VILLAGE OF GERMANTOWN
N112 W17001 MEQUON ROAD
GERMANTOWN, WI 53022

MEETING:	PLAN COMMISSION
DATE AND TIME:	MONDAY, AUGUST 28, 2017 6:30 p.m.
LOCATION:	Germantown Village Hall Board Room

SITE PLAN REVIEW

Plunkett Raysich Architects, agent for the Germantown School District, property owner, has submitted revised landscaping plans for the three (3) school sites for which site development and building plans were conditionally approved in May 2017, including: Germantown High School, Kennedy Middle School and County Line Elementary School.

2300 W. North Avenue
Bloomfield, WI 53006
Phone: (262) 744-5444
Fax: (262) 744-5444
Email: garland@trio.com

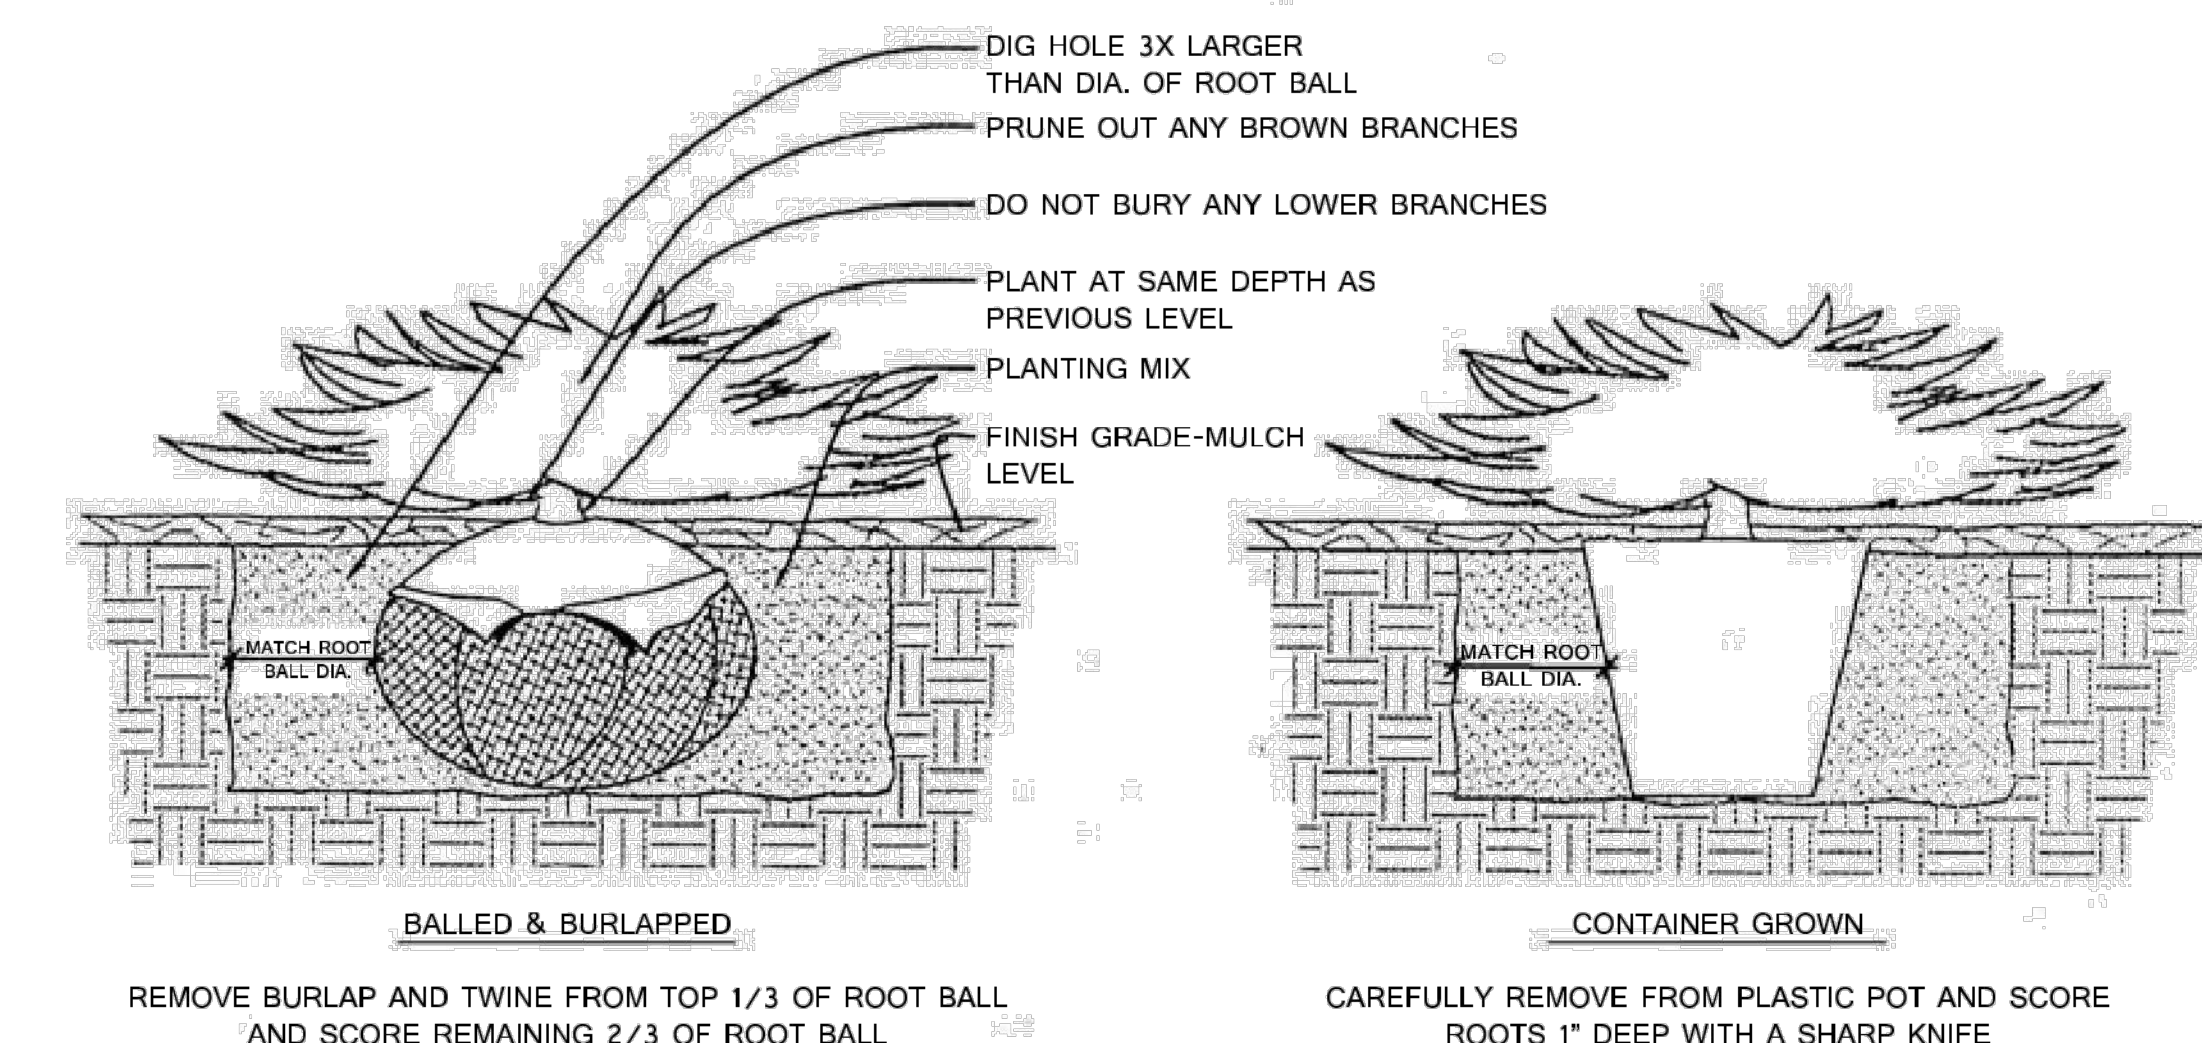
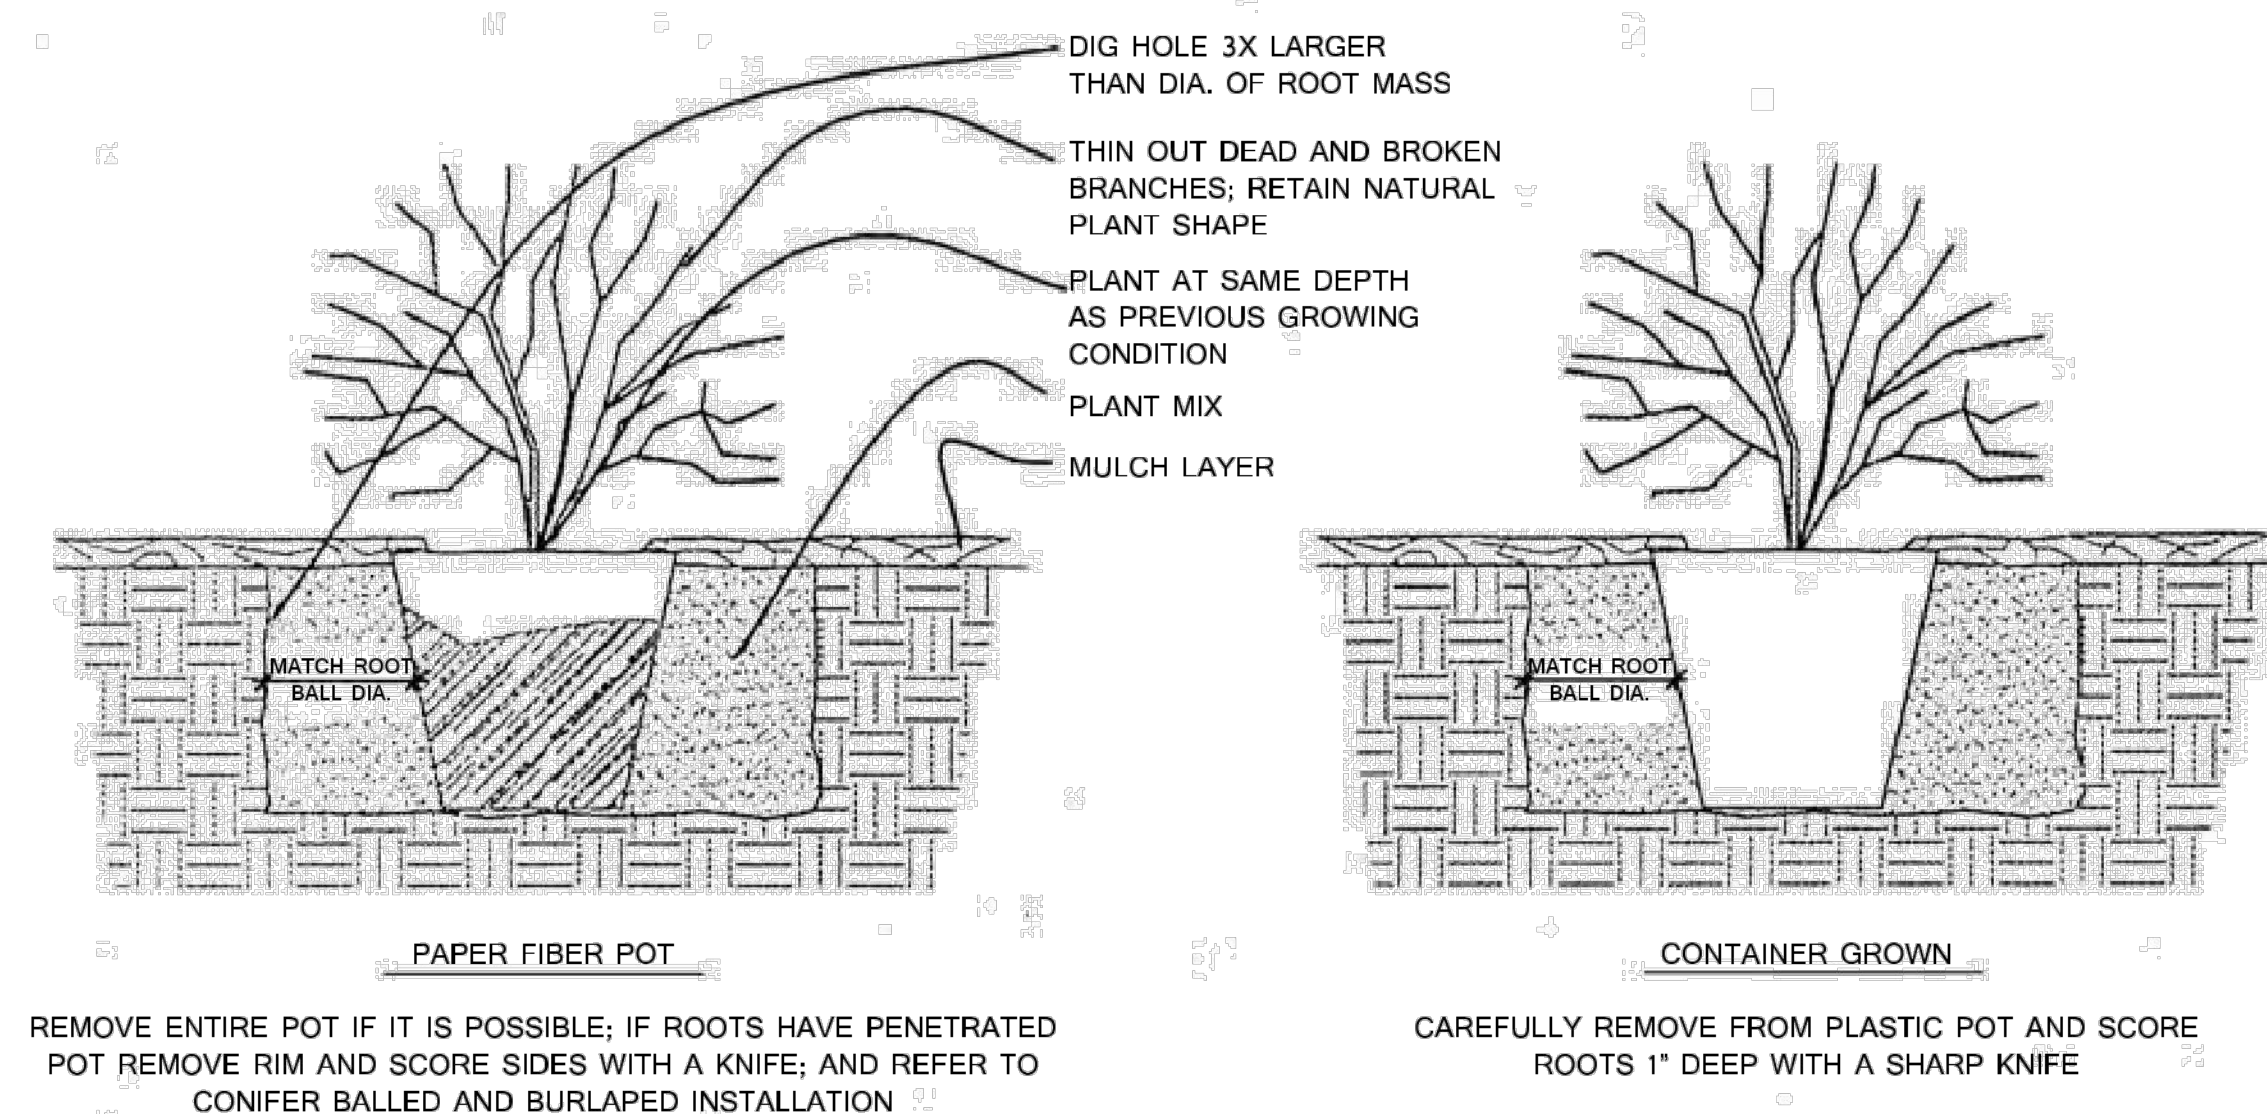
Staff continues to recommend a more substantial landscaping plan for this site given its proximity to the surrounding residential neighborhood (on all sides). As was the case

1. Install an equal number of deciduous trees on the site as compensation for the eight (8) trees being removed to make way for the parking lot in the southeast corner of the site;
2. Install additional street trees along the Butternut Road and School Road frontages in an amount equal to one (1) tree per 50 feet of road frontage in the vicinity of the classroom addition;
3. Install a continuous buffer strip of deciduous and evergreen shrubs along the east and south perimeter of the new parking area in the southeast corner of the site; and
4. Install additional foundation plantings along the west elevation of the gymnasium addition, and, along the south elevation of the classroom addition.

4. The District shall revise the proposed landscaping plan for County Line Elementary to: (a) install eight (8) deciduous trees with a minimum 3" dia on the site in the vicinity of the classroom and gymnasium additions as compensation for the trees being removed for parking lot construction; (b) install street trees along the Butternut Road and School Road frontages in an amount equal to one (1) tree per 50 feet of road frontage in the vicinity of the classroom addition; (c) install a minimum 3' wide landscaped buffer strip of deciduous and evergreen shrubs along the east and south perimeter of the new parking area; (d) install foundation plantings along the west elevation of the gymnasium addition and along the south elevation of the classroom addition.
